**Landmarks Commission  
Special Called Meeting Agenda  
Thursday, May 23, 2024, 8:00 a.m.  
Main Level Conference Room  
Kirkwood City Hall  
139 S. Kirkwood Road  
Kirkwood, MO 63122**

- a. **Case #1-2022 Amended, 150 W. Argonne Drive** (Landmark #77, Heinzelman Bakery Building, Downtown Kirkwood National Register District) – Changes to rear bar area for 4 Hands/Peacemaker restaurant to screen roof top mechanical units.

## 4Hands at The Station Roof Top Condenser and Screening Plan

**4HANDS BREWING CO**  
The Station  
150 West Argonne  
Kirkwood, Missouri

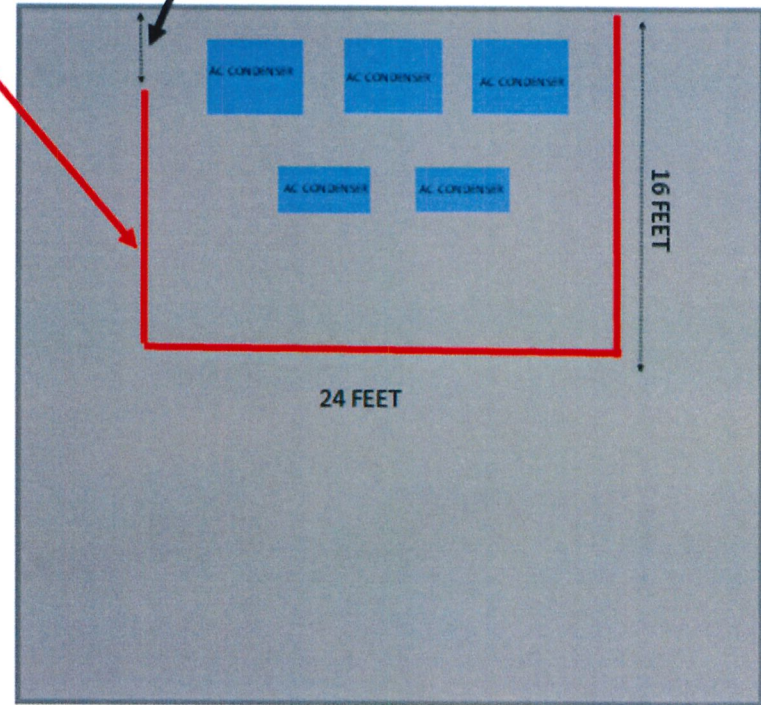
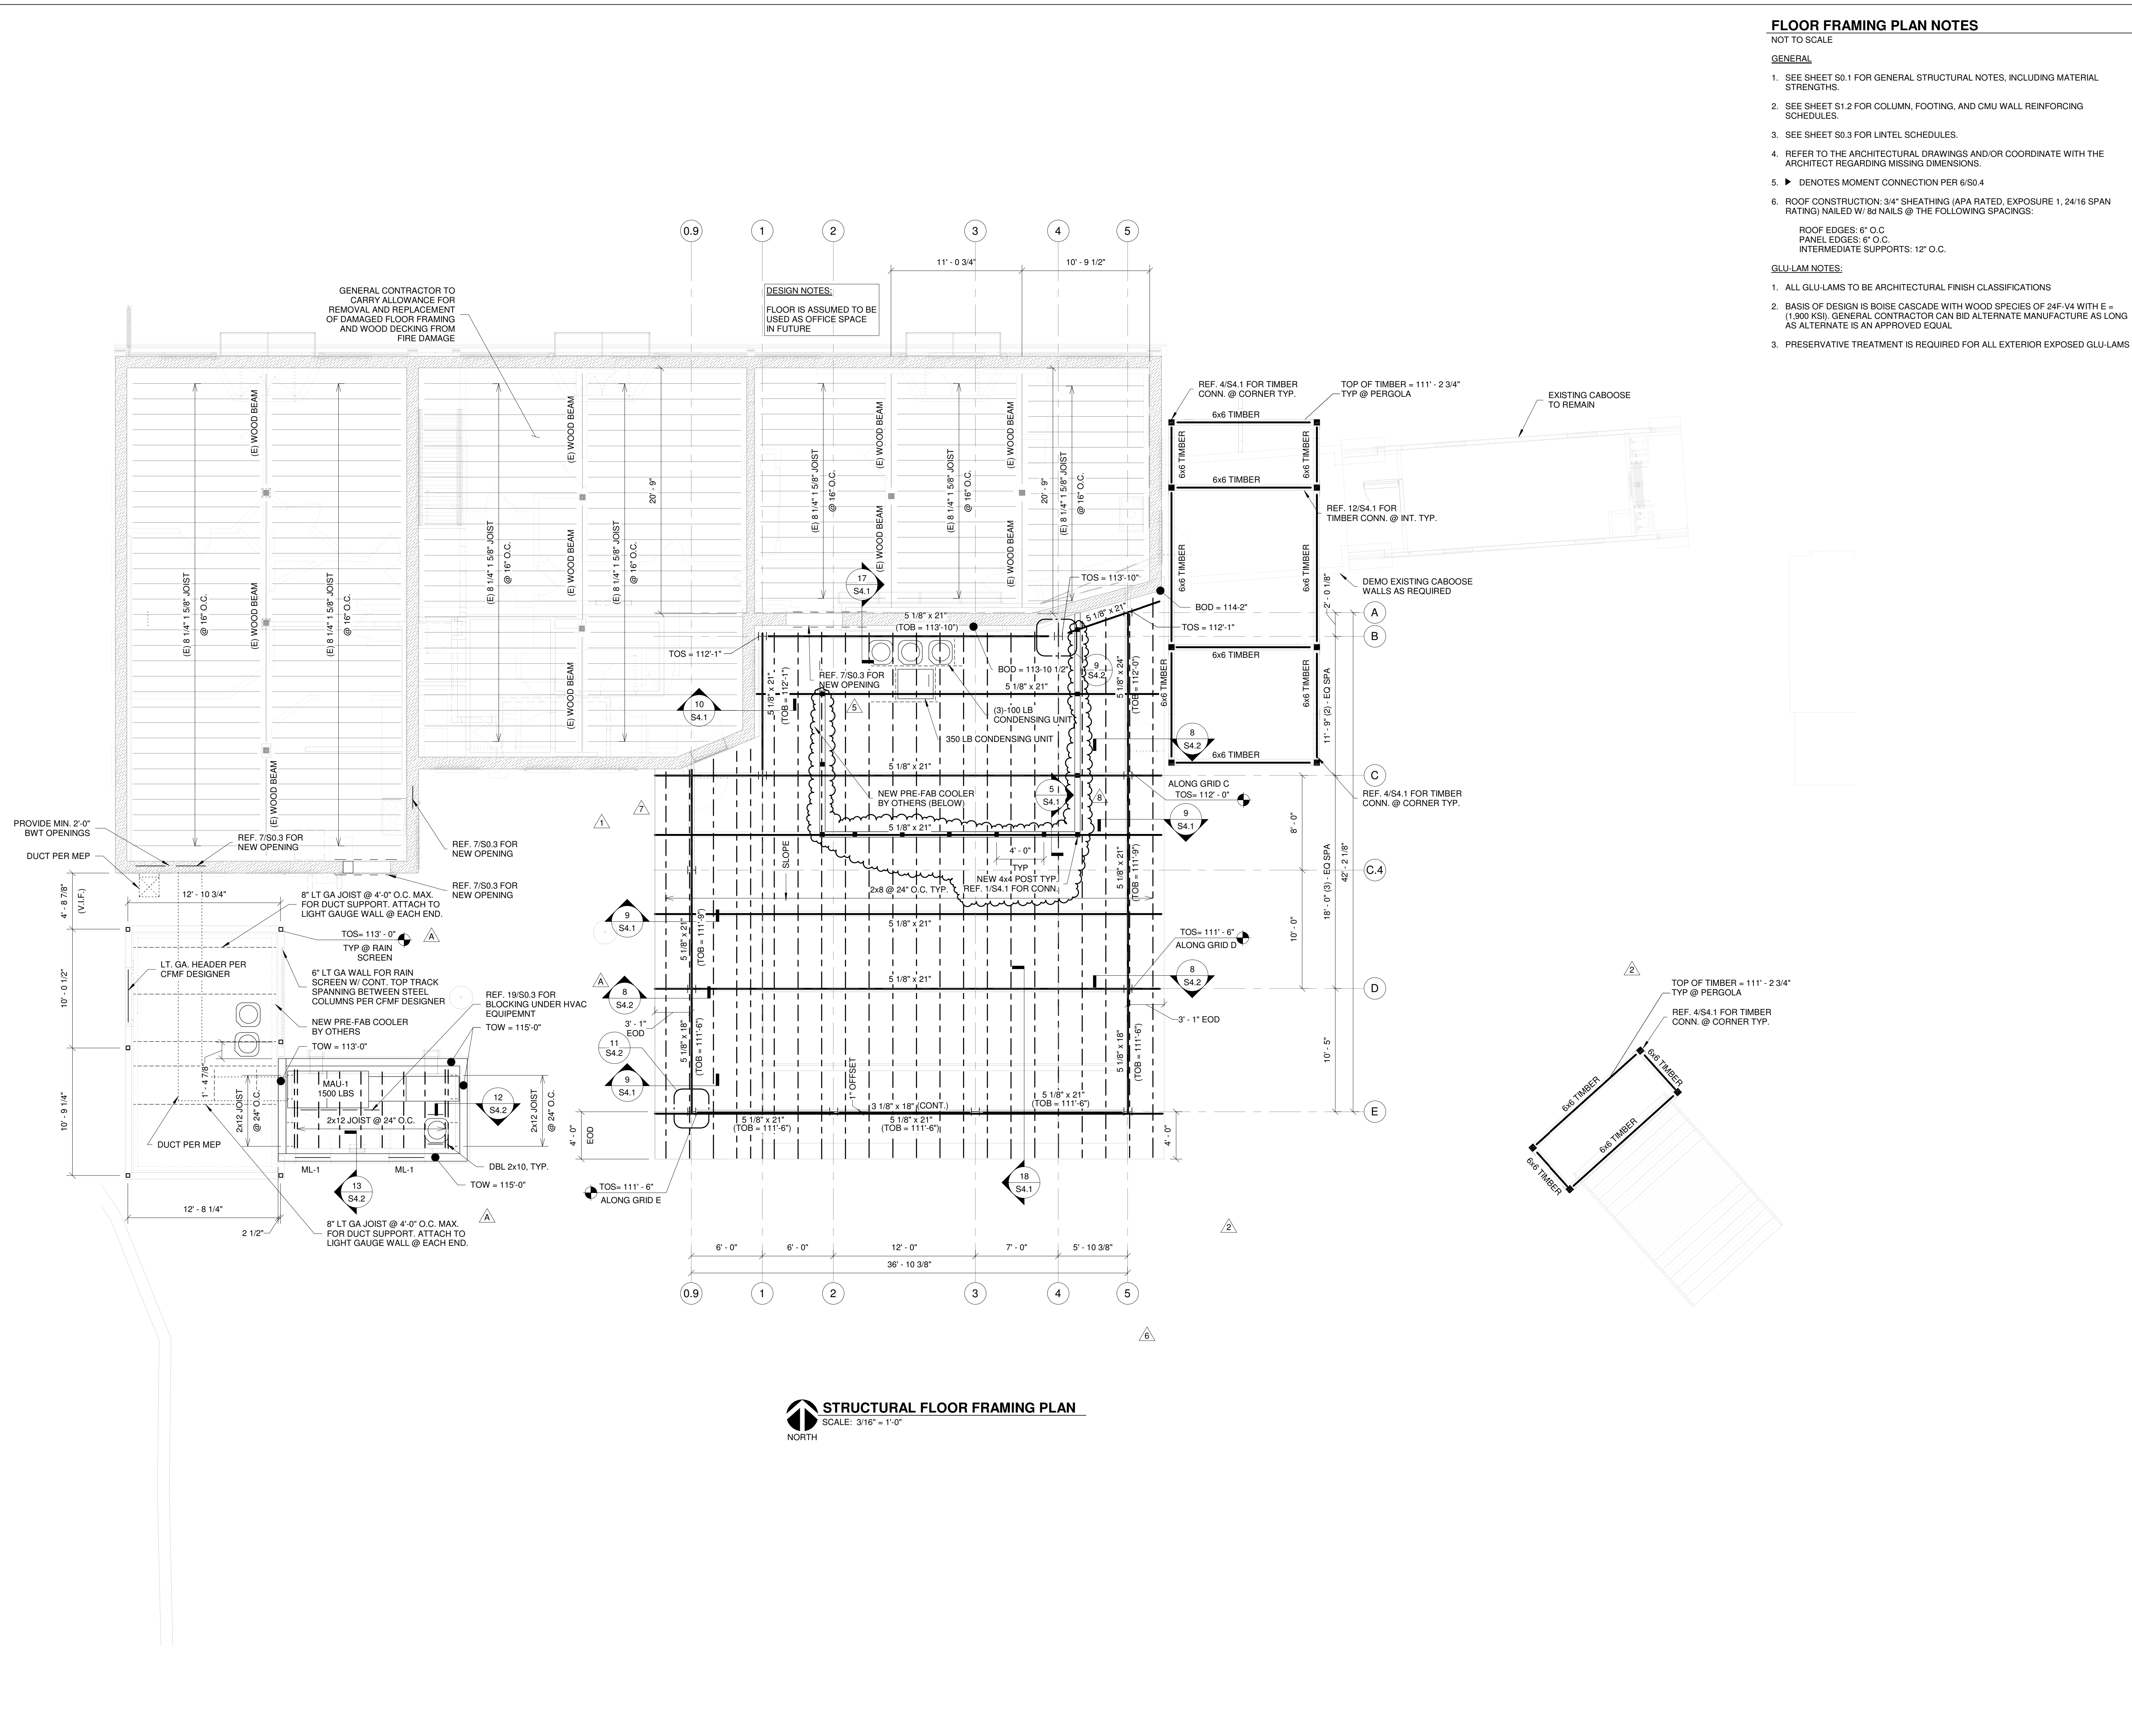
Apprx. 4.5—5ft high screen constructed of same corrugated material as seen elsewhere on the project. See attached photo.

3ft opening for access
